**From:** Mardy Semmler  
**Sent:** November 21, 2017 4:41 PM  
**To:** Conway, Amanda  
**Cc:** Bijaya Adhikari; Freda Wilson  
**Subject:** FW: 17-HCAA-01564 Hamlet of Aklavik Bridge Construction and Culvert Installation - Responses to DFO Information Requests  
**Attachments:** Figure 1 VHWHY03035\_Aklavik\_Culvert.pdf; Figure 2\_Aklavik\_Topo\_R0\_DESIGN-Option1 with piles-SK-01.pdf

Additional information requested by DFO – N3L1-1839 – Hamlet of Aklavik Bridge Construction and Culvert Installation – Bickish Road.

**AKLAVIK BRIDGE**

**CULVERT CROSSING**

Q:\Vancouver\Transportation\TRN\_VHWPY\Projects\TRN\_VHWPY03035\_Aklavik\_Bridge\CADD\Culvert\_Crossing\HWPY03035\_Aklavik\_Culvert.dwg [FIGURE 1] November 21, 2017 - 2:57:46 pm (BY: LAW, YORK)

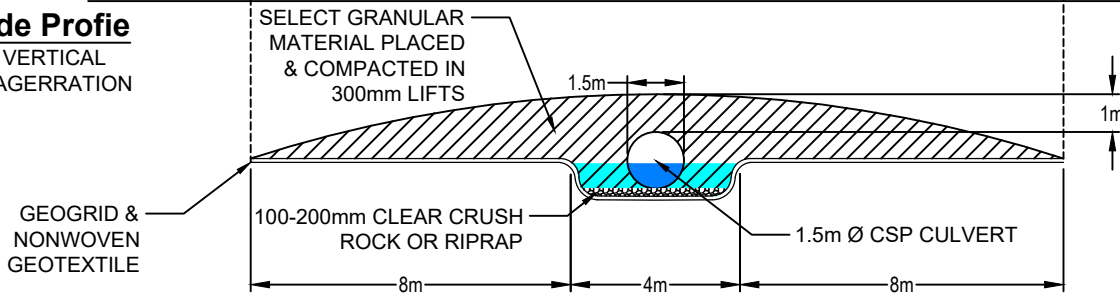
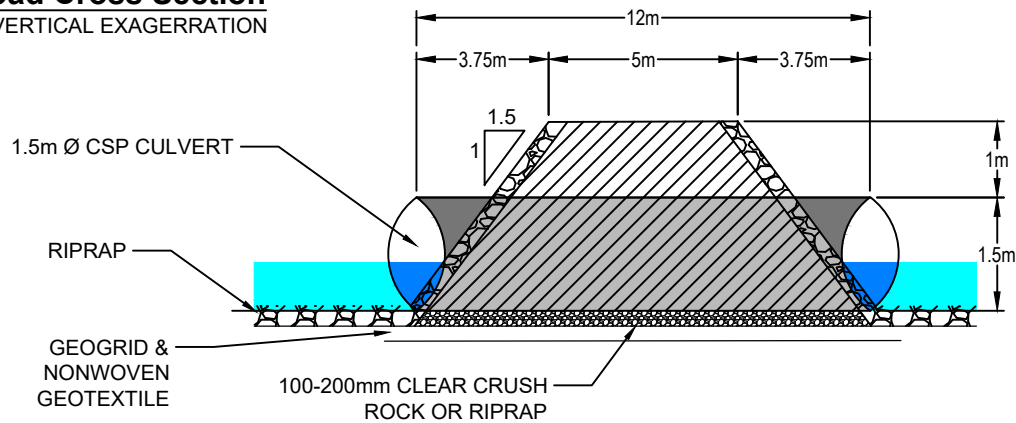
1. The footprint (size of culvert, rip rap placement, fill placement, bank reshaping) in m<sup>2</sup> below the high water mark for the installation of the new culvert /ramp/ water crossing. Are there any technical drawings prepared?

2. Will the new culvert be embedded? Will it pass fish?

Response: The culvert is 12 m long and has a diameter of 1.5 m. Details regarding fill placement, and rip rap placement and other considerations are provided in the attached Figure 1. The banks of the former drainage channel to be crossed at the culvert crossing site will not be reshaped but approximately 8 m of bank on each side of the channel will be infilled to cover the culvert as illustrated in Figure 1. The footprint of fill placement below the normal high water mark of the channel will be approximately 32 m<sup>2</sup>.

To mitigate potential impacts on the underlying permafrost, the culvert will not be embedded into the bed of the former drainage channel. Rather, as illustrated in Figure 1, the culvert will be placed on a 100-200 mm thick layer of clear crushed rock (4 inch), which in turn will be placed on a sandwiched layer of non-woven geotextile fabric and geogrid. The materials placed below the culvert will serve to stabilize and enhance the integrity of the culvert and prevent migration of the crushed rock into the bed of the channel.

As illustrated in Figure 1, channel water is anticipated to fill the lower half of the culvert for most, or all of the open-water season (unless it dries completely, which is not expected to occur). As a result, the small fish species which could potentially frequent this portion of the former drainage channel, in particular sticklebacks and potentially juvenile pike would be able to pass through the culvert.

PROJECT No. TRN.VHWY03035	OFFICE VANCOUVER	DES SM	CKD LQ	REV 0	DRAWING 
DATE OCT 11, 2017	SHEET No. 1 of 1	DWN SM	APP SM	STATUS A	<b>SK-01</b>

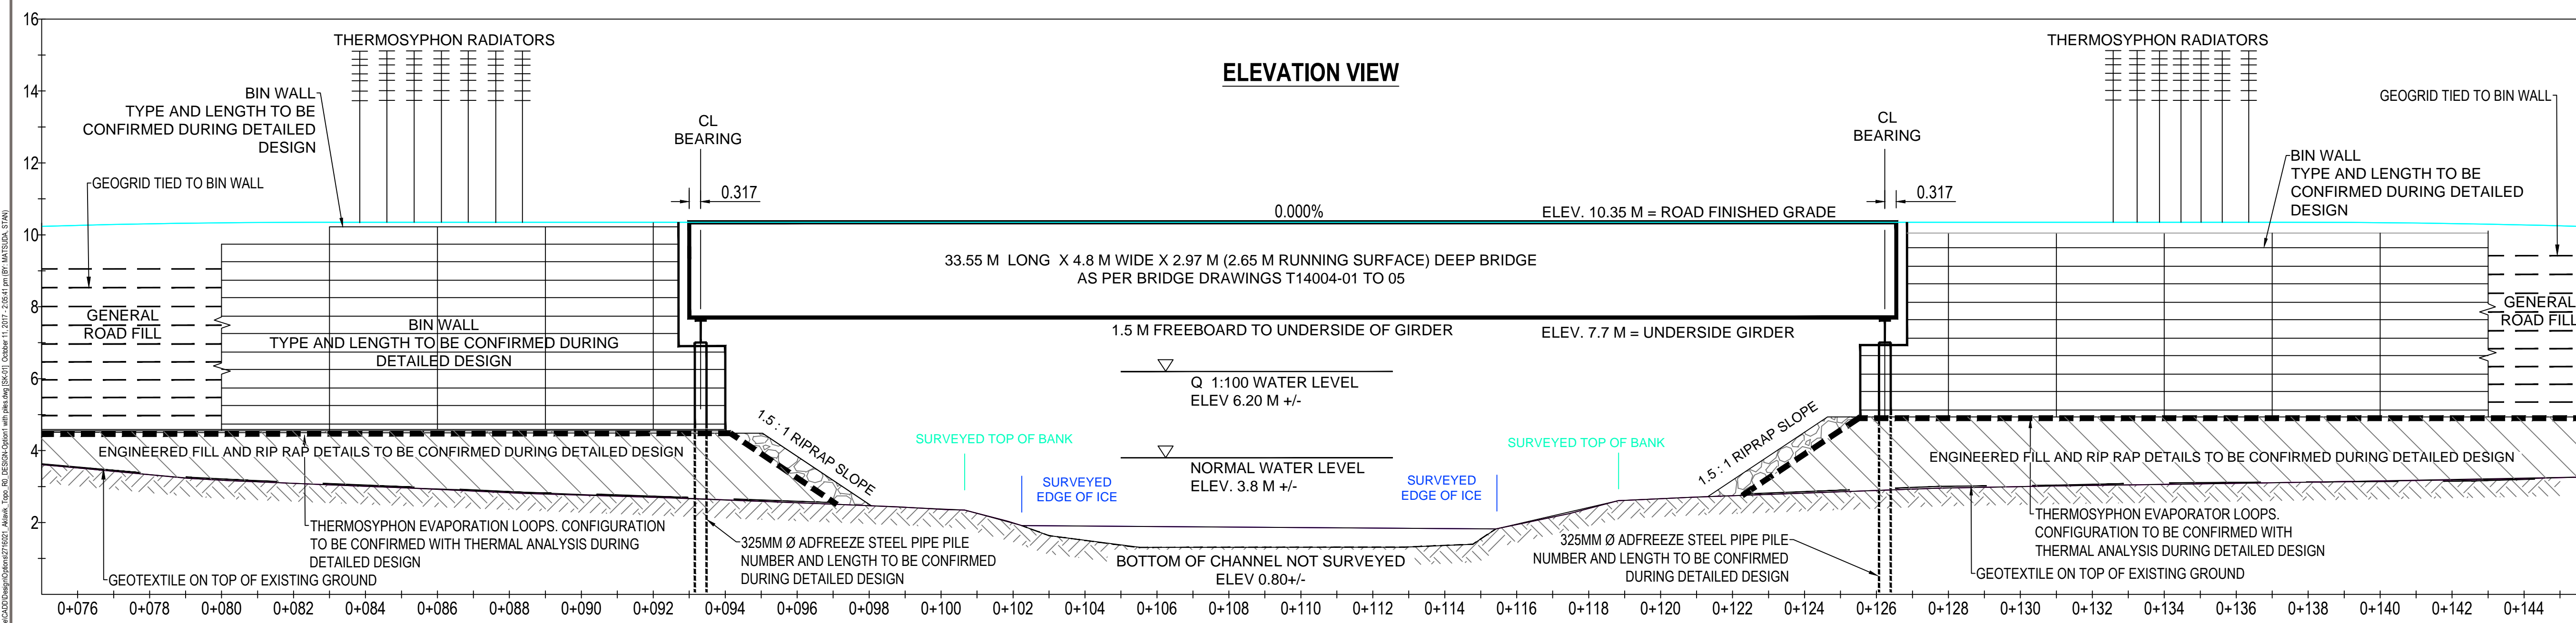
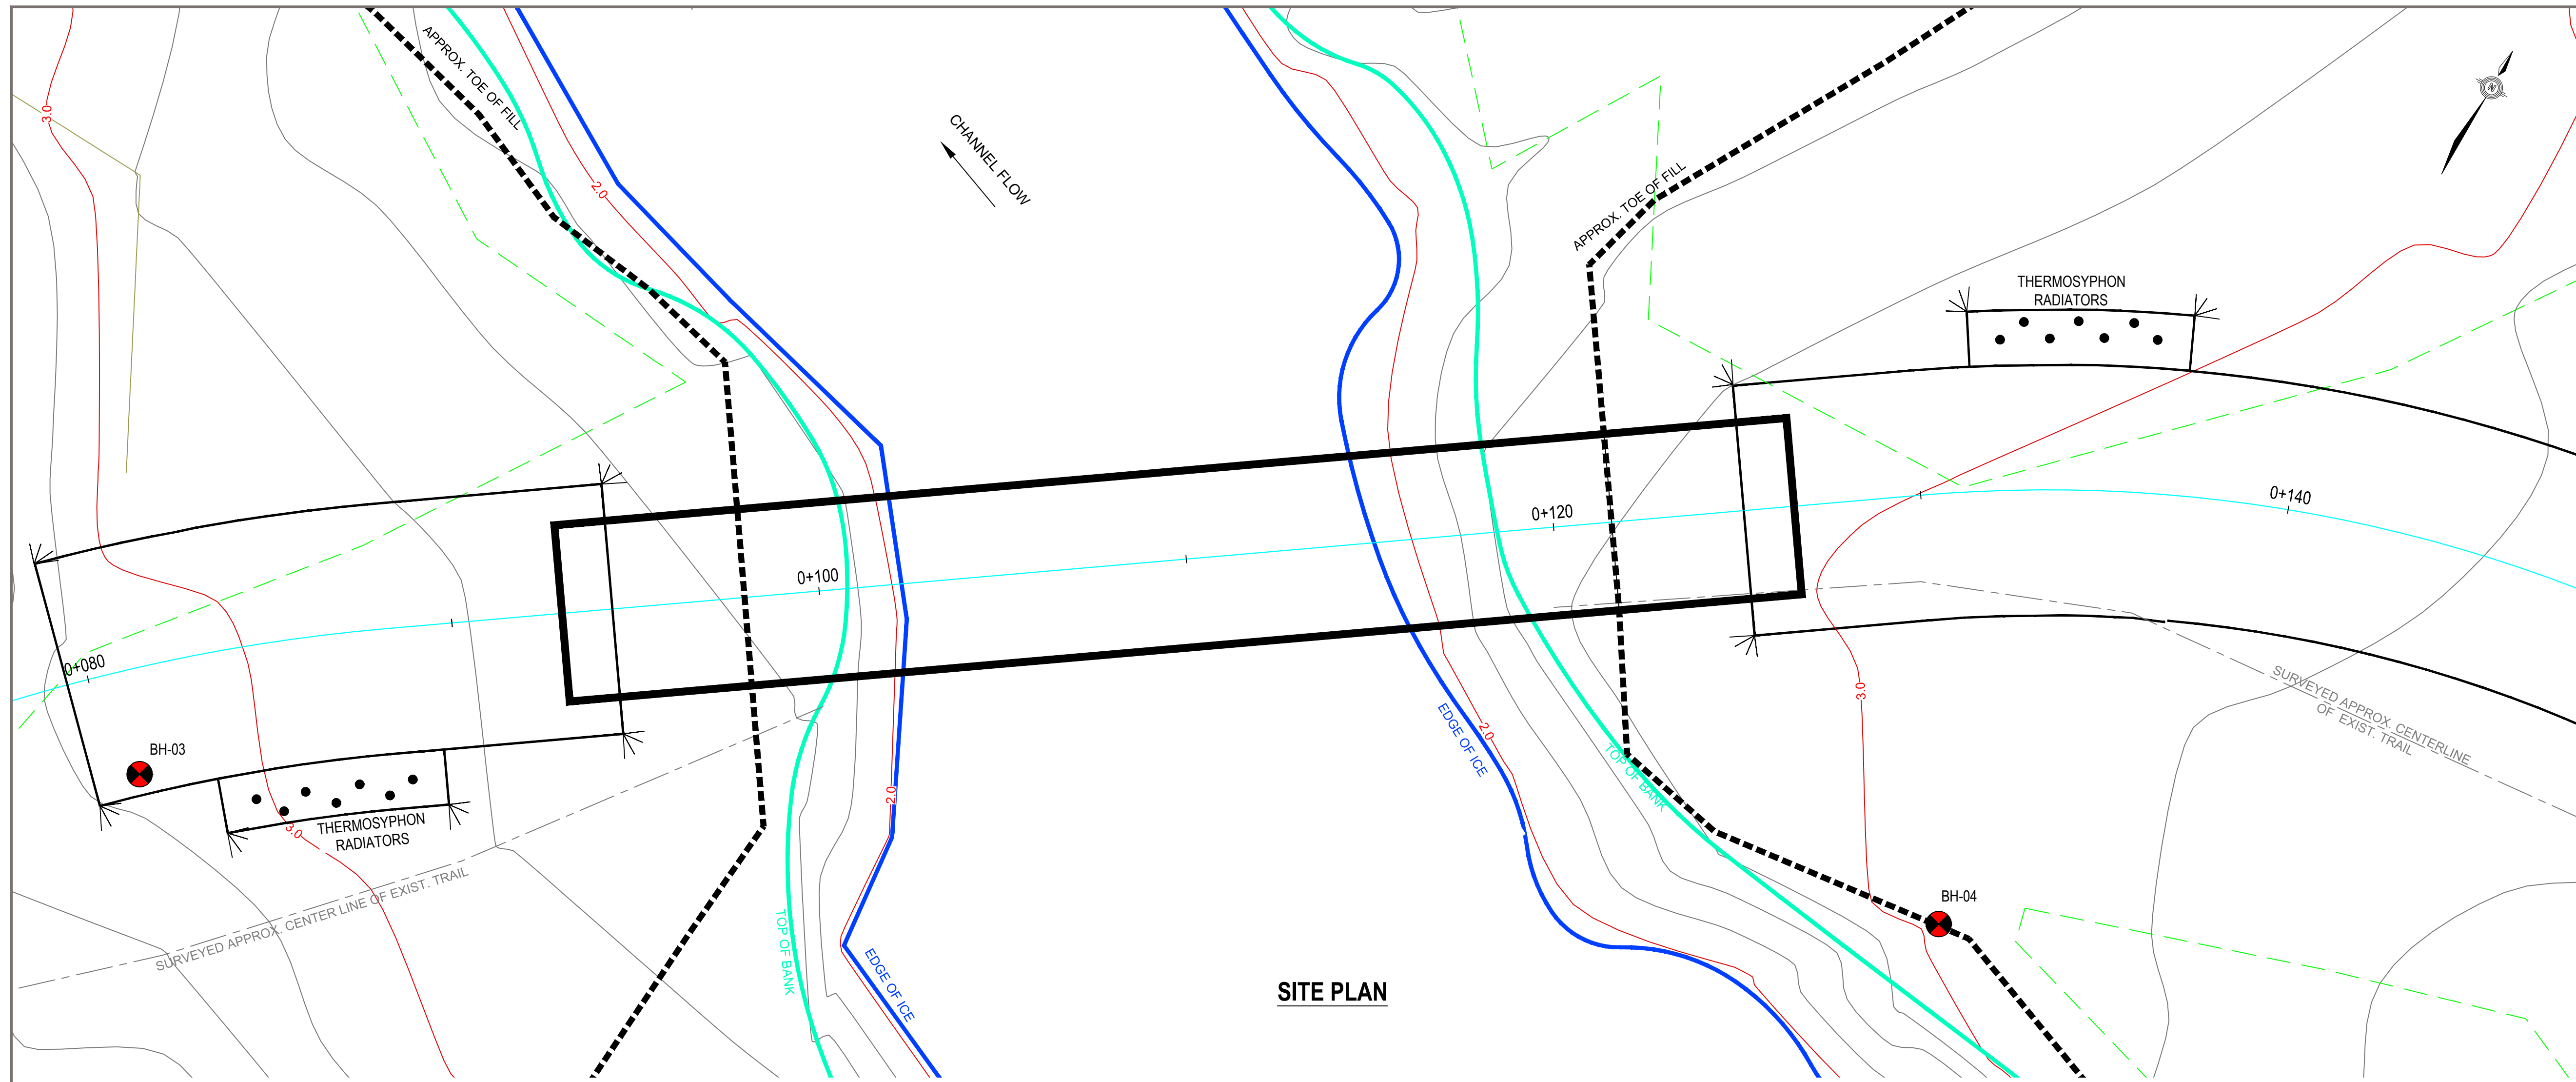
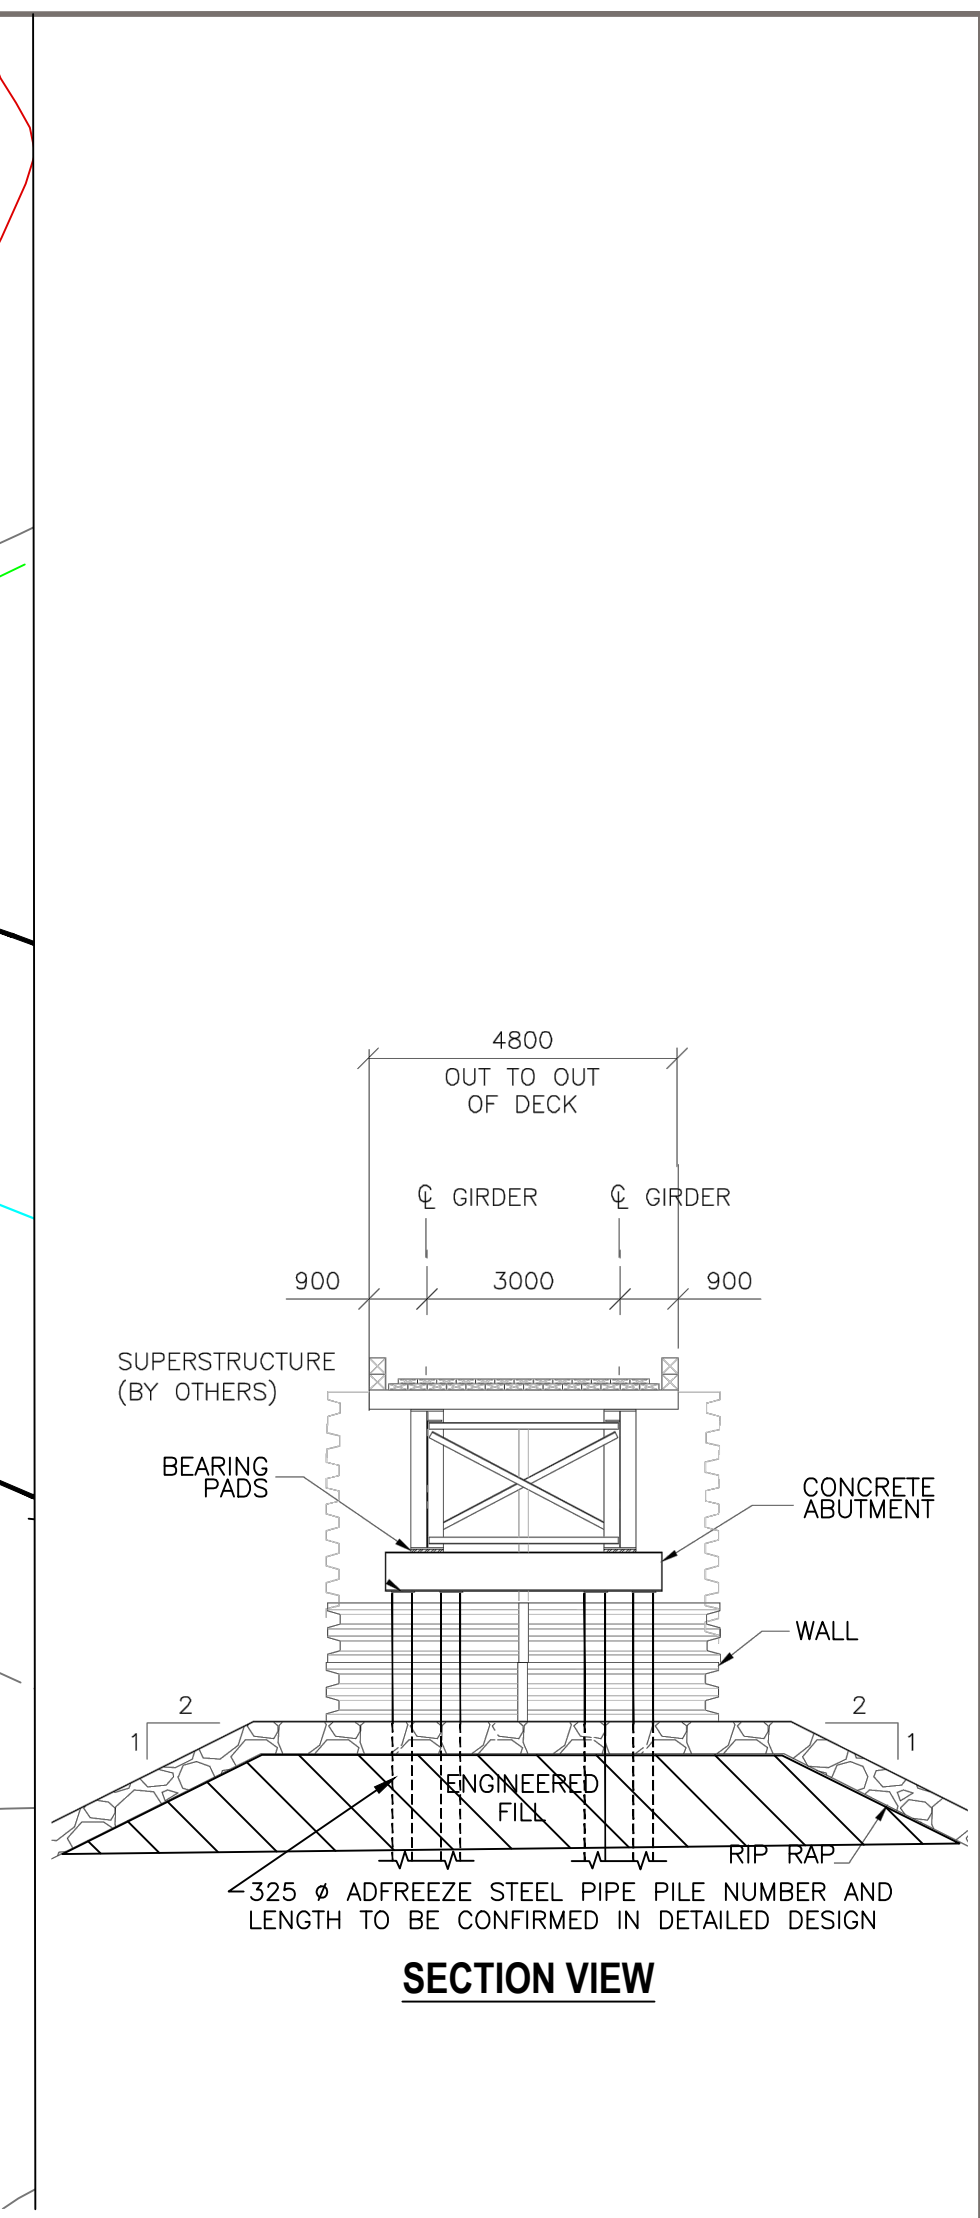
3. The footprint (embankments, rip rap placement, bank reshaping) in m<sup>2</sup> below the high water mark for the installation of the clear span bridge. It looks like it would just be some rip rap, but any clarification is appreciated.

As illustrated in the attached Figure 2, the toes of the rip-rap covered embankment berms on both sides of the clear span bridge are designed to remain several metres away from and up-gradient of the surveyed top of bank of the stream to be crossed by the bridge. As a result no rip-rap is expected to be placed in the stream bed. However, due to temporary seasonal flooding, which is anticipated to occur in most years, all sides of the embankments will be armoured with rip-rap to mitigate possible erosion concerns during seasonal flooding events.
